SB0143

SERVICE BULLETIN

Affected Equipment: TM3 VSD Compressor Drives
658 through 1100HP

Subject: Circuit Breaker Operating Mechanism Retrofit

FIGURE 1 - RIGHT SIDE

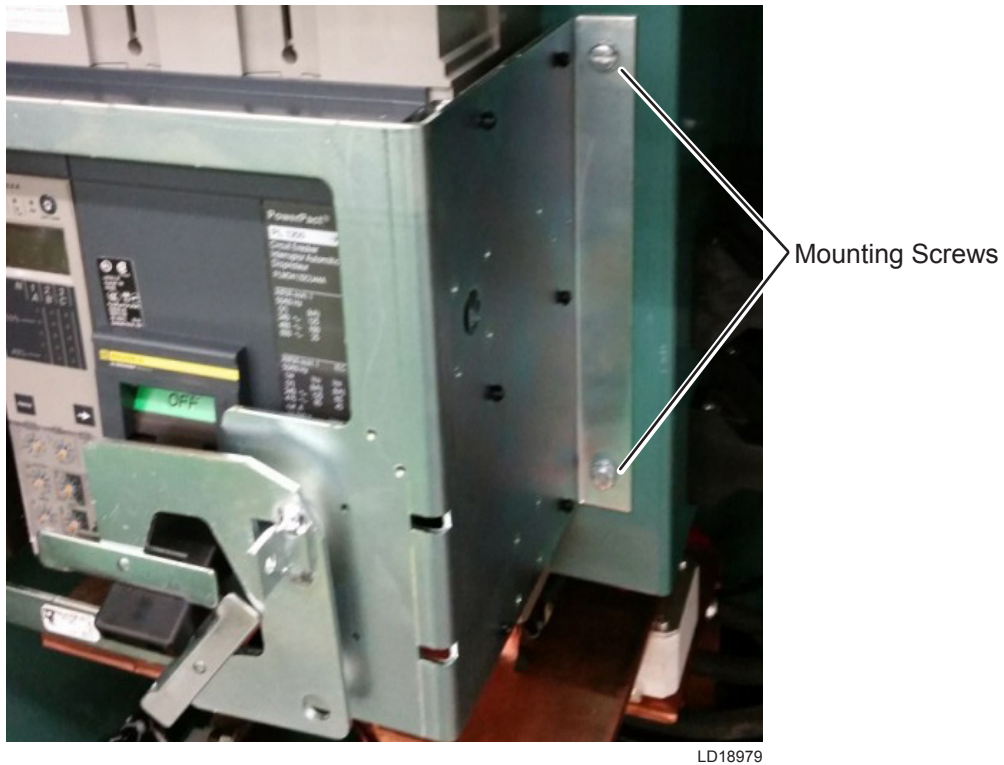
The bracket on the circuit breaker that holds the operating lever assembly contains a snap ring that holds the assembly in place. The groove for the ring was manufactured incorrectly, and the ring may not seat in the groove as designed. This may cause the shaft to pull out of the circuit breaker bracket and make the circuit breaker inoperable. Also, the ring may fall into other electrical contacts and cause a short circuit.

1. Stop the chiller, remove all power to the VSD, and lockout/tagout. Wait 5 minutes for the bus capacitors to discharge.
2. Open the panel and verify with a voltmeter that the bus is discharged.
3. Remove the four screws (two on each side) holding the bracket to the circuit breaker, and remove the bracket.
4. Install the new bracket and secure with the four screws.

The entire bracket must be replaced. Failure to perform this task may cause damage to the equipment and/or possible harm to personnel.
